STERLING RECYCLING FACILITY SITE DEVELOPMENT PLAN & FINAL PLAT

LETTER OF INTENT

SEPTEMBER 2023

PCD File # PPR2341
& SF2325

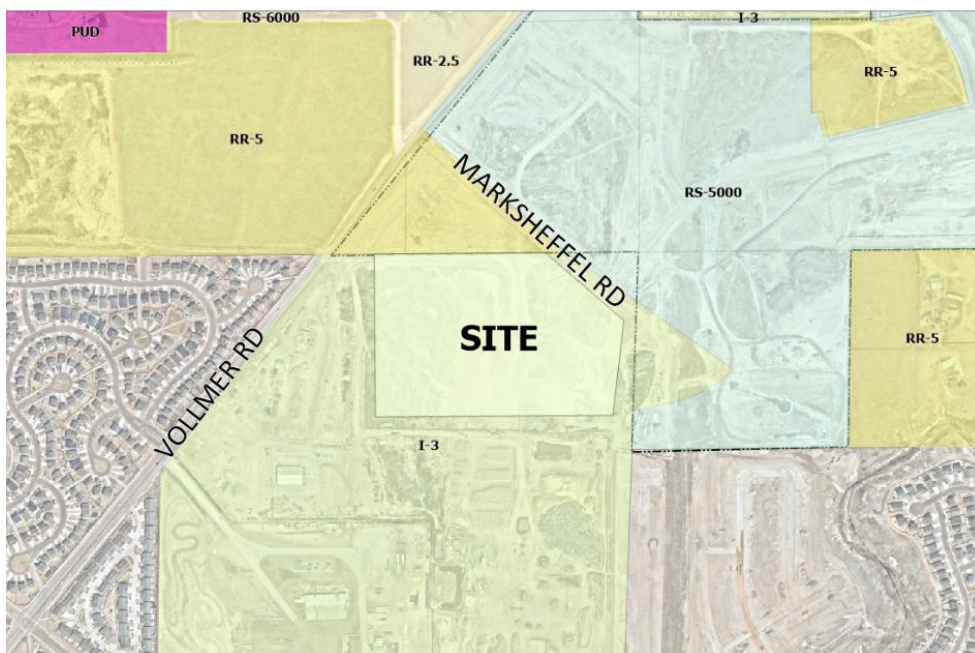
wholesale operations would indicate material stockpiling and storage for sale. This seems incongruent for typical recycle yard operations.
